Model: Stella-C2	Date: 29-Jun-04	No.: MB129001a
------------------	-----------------	----------------

## MB Correction

Modified Article: Parts Catalog Correction		Prepared by: M. Ishihara	
From: 1 <sup>st</sup> Tech. Support Sec. Service Support Dept.			
Reason for Modification:	<input checked="" type="checkbox"/> Parts catalog correction	<input type="checkbox"/> Vendor change	<input type="checkbox"/> To meet standards ( )
	<input type="checkbox"/> To facilitate assembly	<input type="checkbox"/> To improve reliability	
	<input type="checkbox"/> Part standardization	<input type="checkbox"/> Other

## Page 6

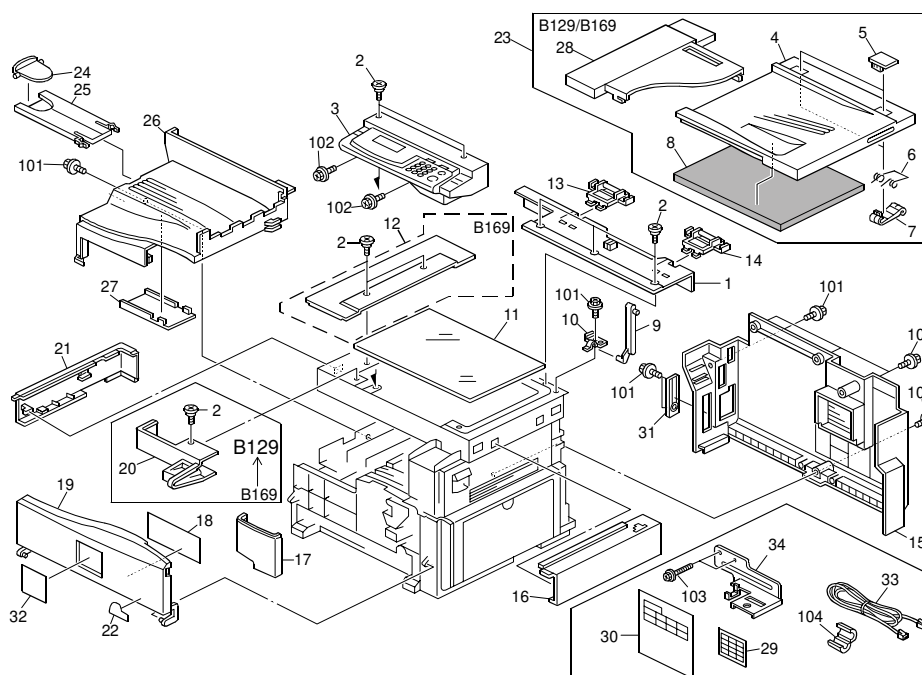
- Illustration Correction -

## Page 7

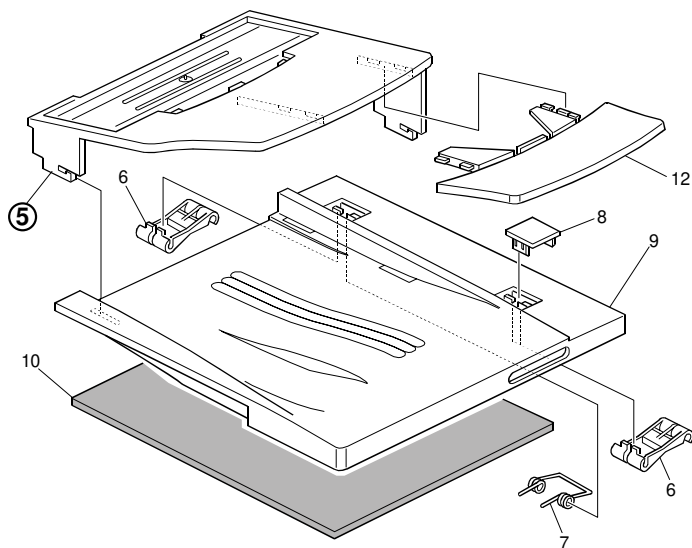
- Description Correction -

Part number	Incorrect description	Correct description	Q'ty	Index	Note
B1297508	Model Name Plate (B129 RIC TWN)	Model Name Plate – GES DSM415	1	32	
B1307508	Model Name Plate (B130 RIC TWN)	Model Name Plate – GES DSM415PF	1	32	
B1687508	Model Name Plate (B168 GES)	Model Name Plate – GES DSM415F	1	32	
B1687514	Model Name Plate (B168 GES)	Model Name Plate – REX DSM415F	1	32

## Page 28

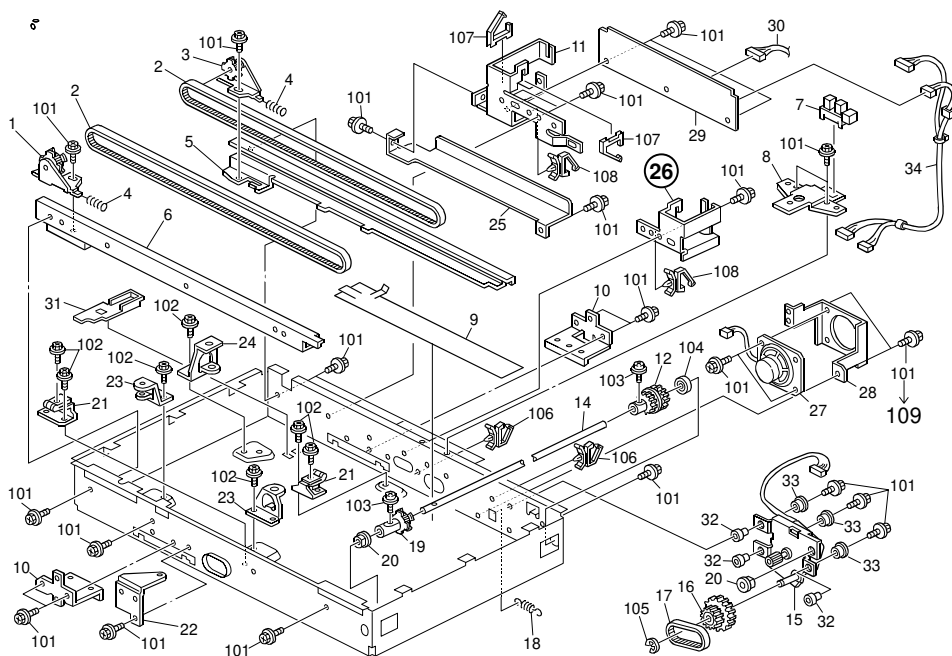
- Illustration Correction -

## Page 29

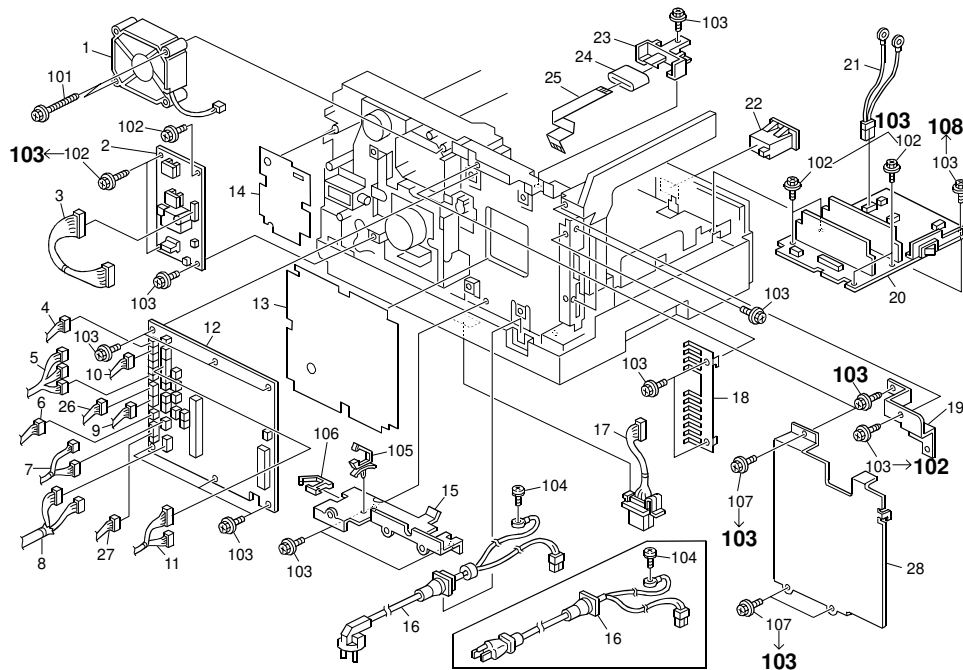
- Addition -

Part number	Description	Q'ty	Index	Note
04533006N	Tapping Screw – M3x6		109

## Page 40

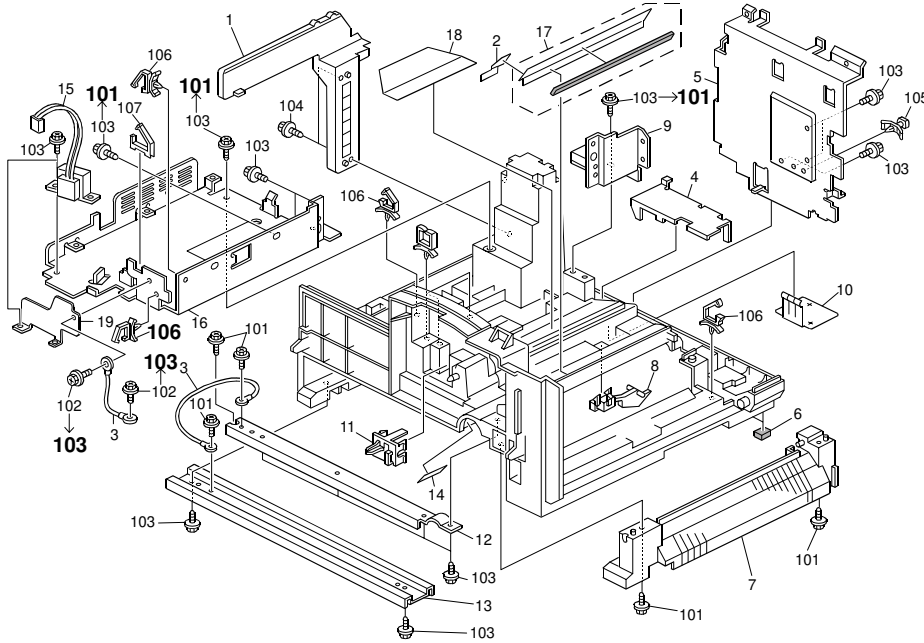
- Illustration Correction -

## Page 44

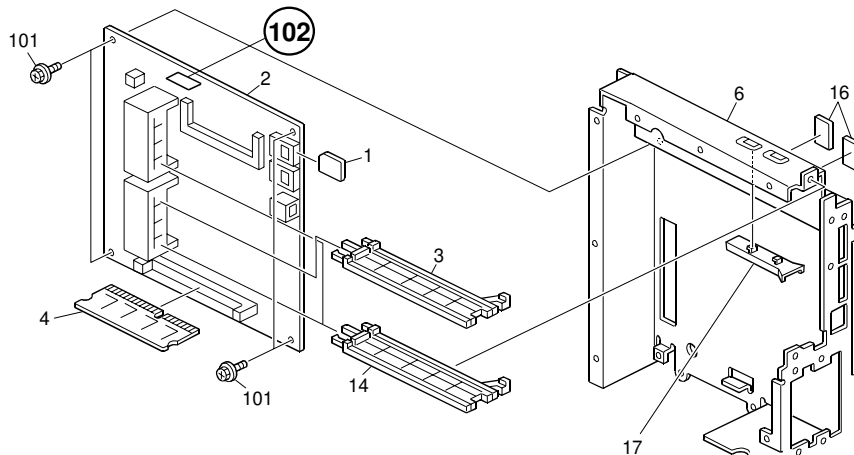
- Illustration Correction -

- Addition -

Part number	Description	Q'ty	Index	Note
14075856	RAM – FM18L08-70-P	1	102

## Page 38, 39

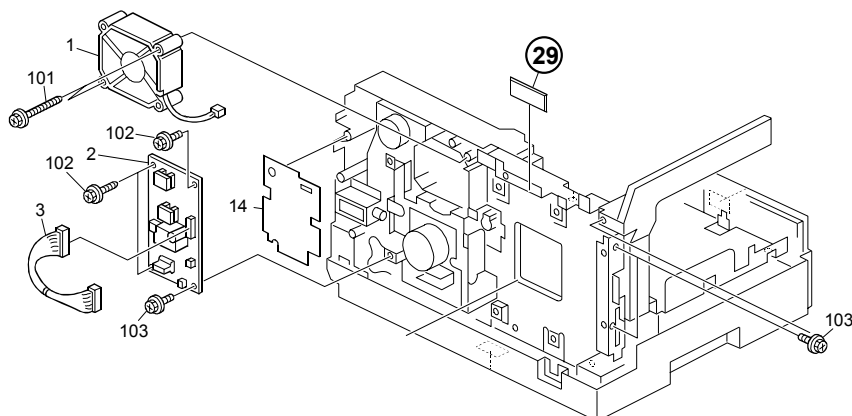
- Addition -

Part number	Description	Q'ty	Index	Note
B1295170	PCB DFB	1	29

## Page 38, 39

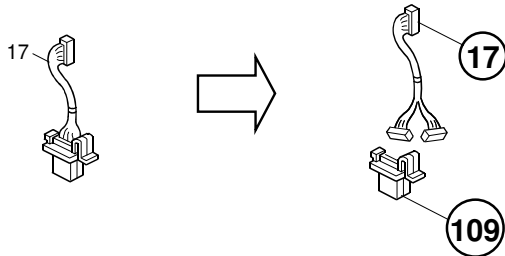
Please correct the parts catalog as follows.

Part number	Description	Q'ty	Int	Index	Note
B1295223	Harness – Paper Feed Table	1		17	
11028534	Connector – OR/P17 – 14S - B	1		109

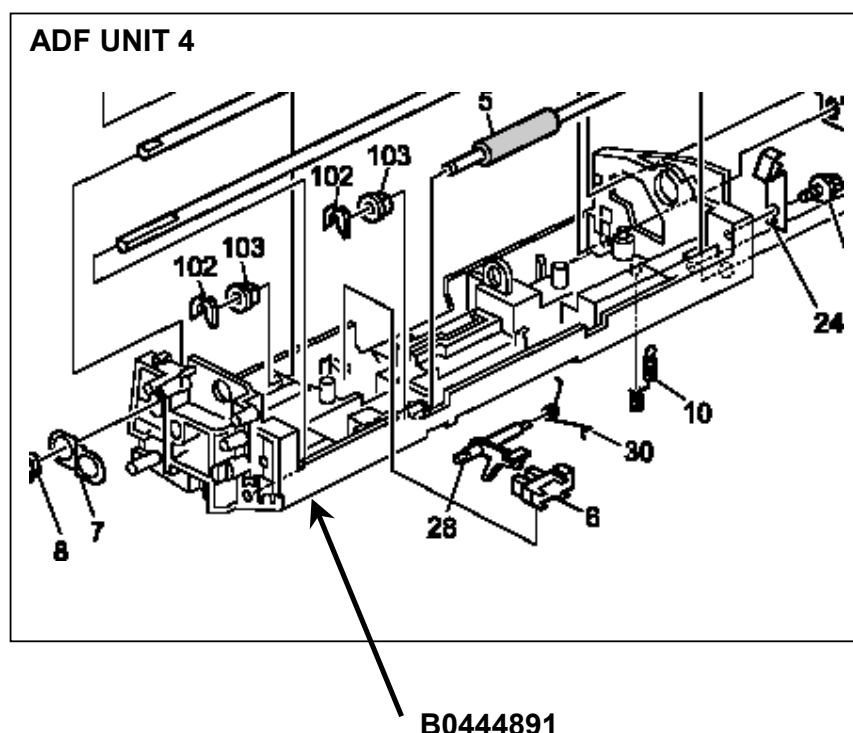
Old part number	New part number	Description	Q'ty	Int	Page	Index	Note
	B0444891	Base	0→1	-/-	25	30

**Change:** This part was added.

**Reason:** It was missing from the Parts Catalog.

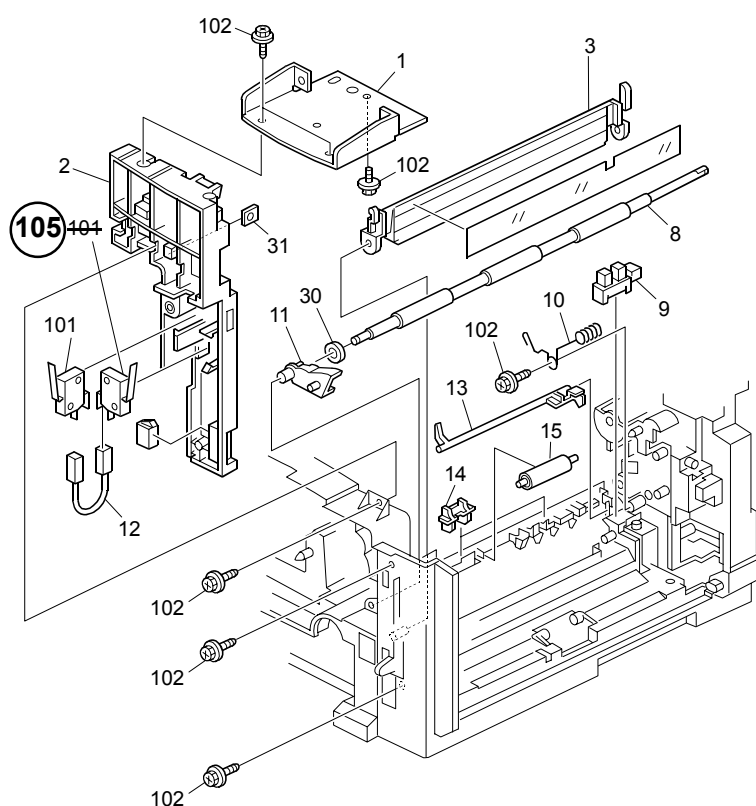
Old part number	New part number	Description	Q'ty	Int	Page	Index	Note
B6835700	B6835701	PCB CTL EXP	1-1	X/O	45	2

**Change:** A jumper wire was added and a resistor (R524) was removed from the controller board.

**Reason:** To improve the power distribution to the Piccolo ASIC.

**Note:** This change was applied to the machine production line from October 2004.
